AMENDMENTS TO THE DRAWINGS

REMARKS/ARGUMENTS

EDWIN et al.
Appl. No. 10/507,493
June 30, 2006

Fig 1

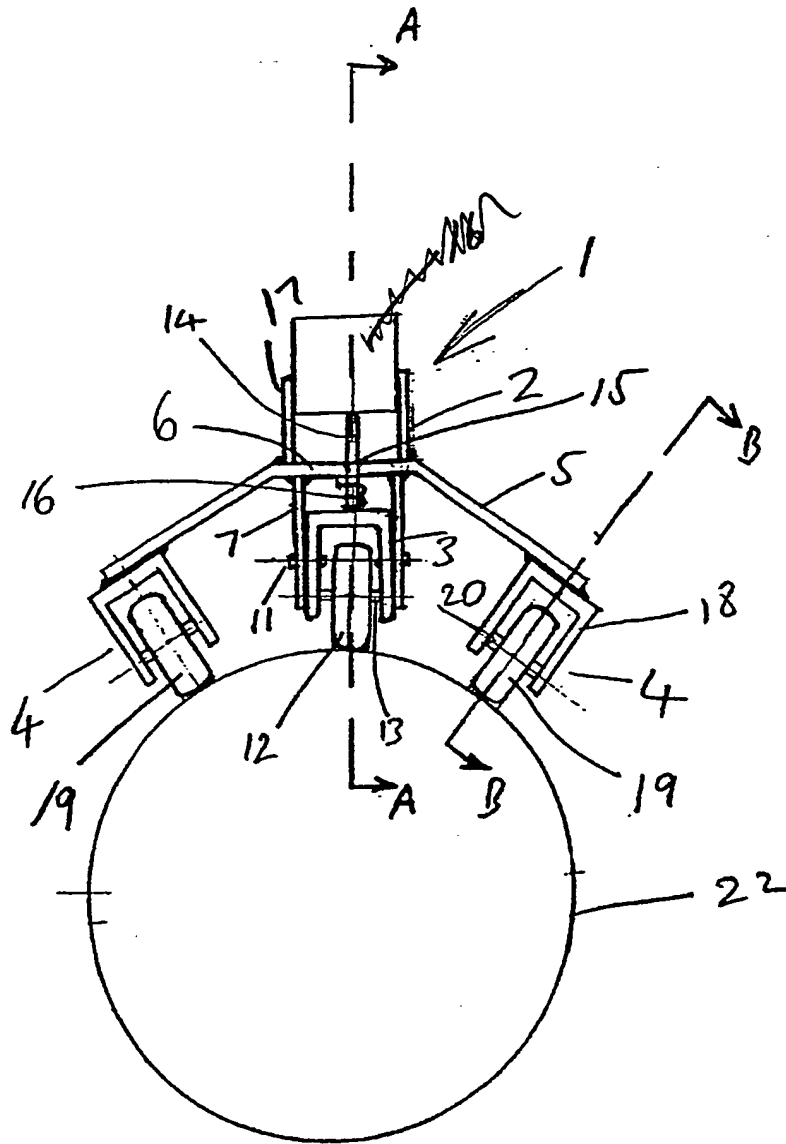
The attached sheet of drawings includes changes to Fig. 1. This sheet, which includes Fig. 1, replaces the original sheet including Fig. 1. In Figure 1, repeated reference numeral 16 has been deleted.

FIG. 1 has been amended to delete the repeated use of numeral ‘16.’ An annotated drawing sheet and a replacement drawing sheet are attached. Withdrawal of the objection is requested.
